LAND USE APPLICATION
Preliminary Subdivision

For Office Use Only: FILE # PA105821 CODE: DASUB

IDYLEWOOD 4TH ADDITION
COASTAL OVERLAY SETBACKS
 14 MARCH 2012
 FLORENCE, OREGON

Figure 5-1: Florence Northwest Region

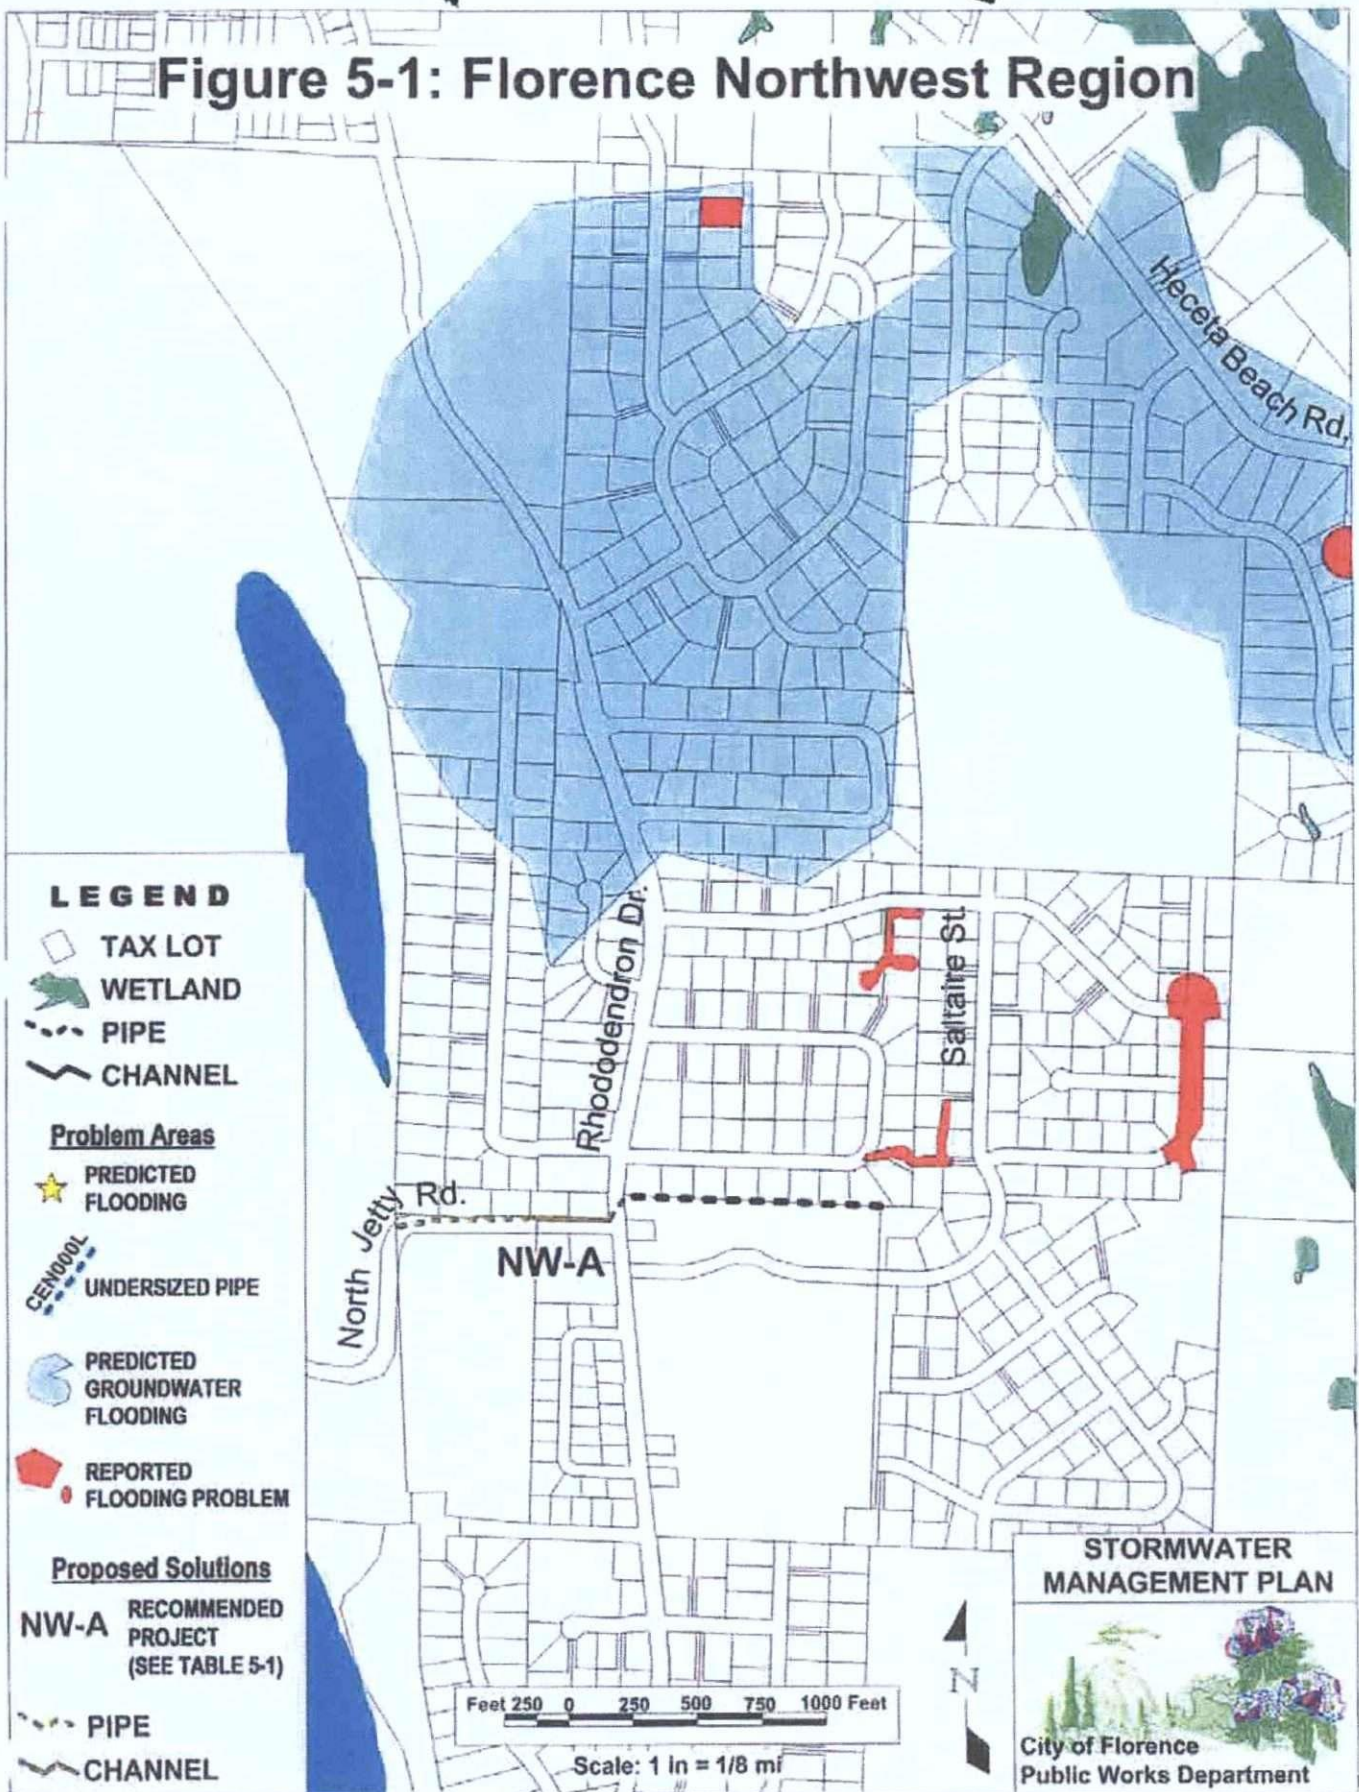
The property is not mapped as a "flood hazard area" as identified in the adopted Flood Insurance Rate Maps. However, a portion of the land of this proposal may be subject to flooding during heavy coastal rain events as shown in photographs in LMD from Idylewood & Idylewood 2nd Addition taken in 1996, information from the Lane County Coastal Resources Management Plan (CRMP), and the City of Florence Stormwater Management Plan (refer to Figure 5-1). Therefore, this proposal is a concern to LMD Floodplain staff.

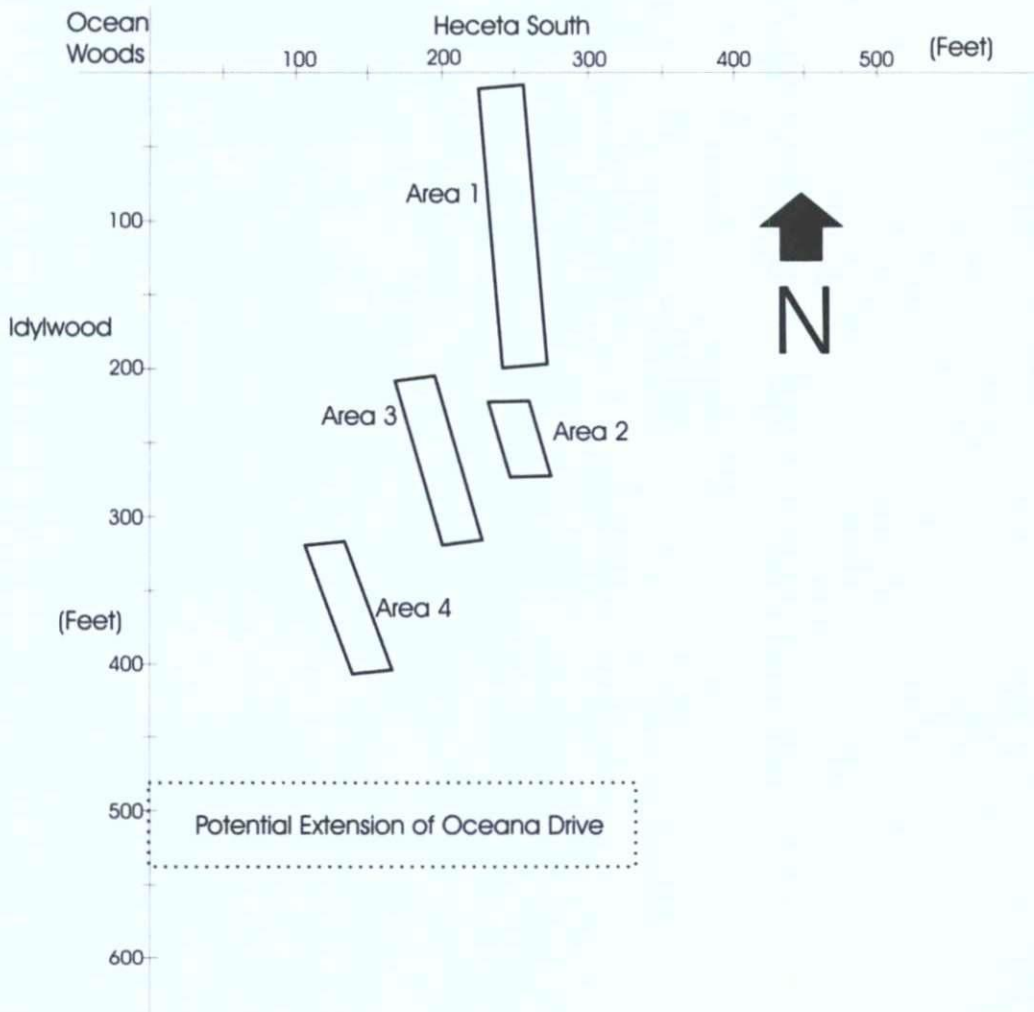
Aerial photographs taken in the summer of 1998 had suggested that other areas of wetlands were present to the south and west of Area 1. One such photograph is shown below:

Access to these areas was not realistic until the recent removal of extensive vegetation. Following the rains this winter the areas with possible wetlands were explored. In addition to one area (Area 2) just south of Area 1 that was accessible during the summer, two additional areas (Areas 3 & 4) have now been identified. For orientation purposes, the approximate locations of Areas 1, 2, 3 & 4 are shown in the drawing below. The sizes of these areas are very rough estimates, since it was not possible to easily measure them. Viewing their relationships to various homes on the ground and from aerial and satellite photos established their approximate locations. The presence of other wetlands in this area cannot be precluded from our observations.
